# PACKARD MOTOR CAR COMPANY

To PACKARD DISTRIBUTERS AND DEALERS

July 8, 1937

Subject VAPOR LOCK

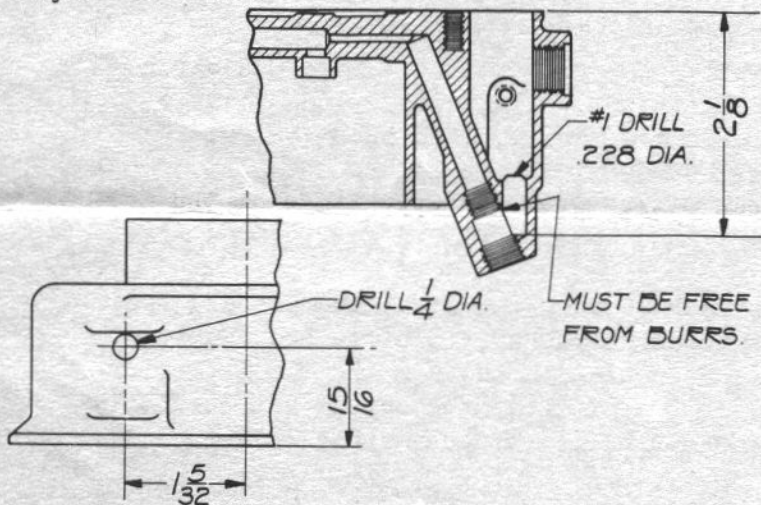
1. Replace the air horn gasket with a new gasket which has been cut out to provide easier disposal of any fumes which may collect in the float chamber.

2. Drill an additional vent hole in the air horn, as shown in the illustration. This is for the same reason.
3. Replace the main metering jet with the latest design. This new design prevents gas from pocketing. While doing this, make sure that the passage supplying the fuel to the main metering jet has no overlapping burrs at the lower end which will enable a gas pocket to form. If necessary the passage should be drilled out with a #1 drill, .228 in diameter, making sure not to drill so deeply as to injure the seat. Do not drill deeper than 2 1/8" from the upper face of the carburetor body.

4. Replace the die cast spacer between the float chamber and the carburetor throat with three of the new throttle body gaskets. These are used to provide insulation between the float chamber and the body. Be very sure that the three screws are perfectly tight, otherwise the gaskets will pound out and air leaks will develop.

- 1 22R-1 Main Metering Jet
- 1 8R-16 Air Horn Gasket
- 3 8R-15 Throttle Body Gasket

These parts form an equipment which may be ordered by calling for CG-3A.
